**TERMINATING SENDER FRAME
EQUIPMENT DESIGN REQUIREMENTS
NO. 1 CROSSBAR SYSTEM**

1.001 This addendum supplements Section 816-505-150, Issue 13.

Fig. 1— Terminating Sender Frame

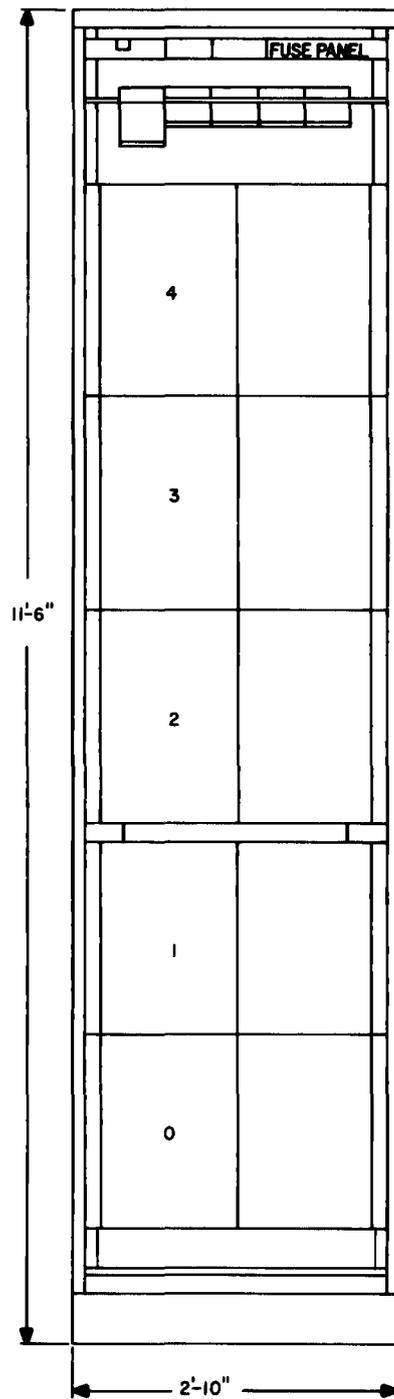
(a) Figure 1—revised

(d) Under Subdivisions of Equipment and Detailed Index, J28050N—added
